**Customer** Smallfry Industrial Design  
School Street, Wolston  
Coventry  
CV8 3HG  
UK  
Att.: Steve May-Russell

**Quotation no.** 071207/1 **Blue Ox spring parts**

QUOTATION

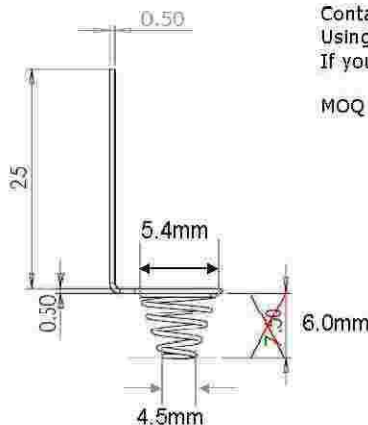
Should have been in original quotation

Contact 1 and 2 will be with a standard coil and assembled with rivets  
Using a standard coil means that dim 7.50 will change to 6.0 - hope this is OK?  
If you want your own coil dimension the MOQ will be 20.000pcs

needs spring and plate at each end

What happened to photo screw thread

MOQ if you can use a standard coil is 1000pcs

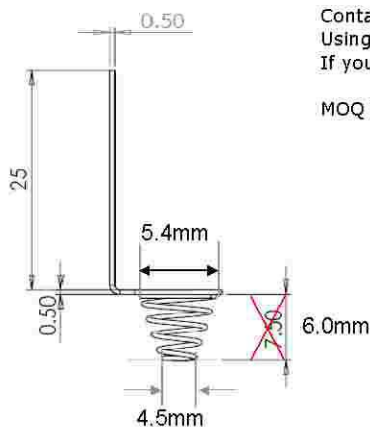
Contact 1 and 2 will be with a standard coil and assembled with rivets  
Using a standard coil means that dim 7.50 will change to 6.0 - hope this is OK?  
If you want your own coil dimension the MOQ will be 20.000pcs

MOQ if you can use a standard coil is 1000pcs
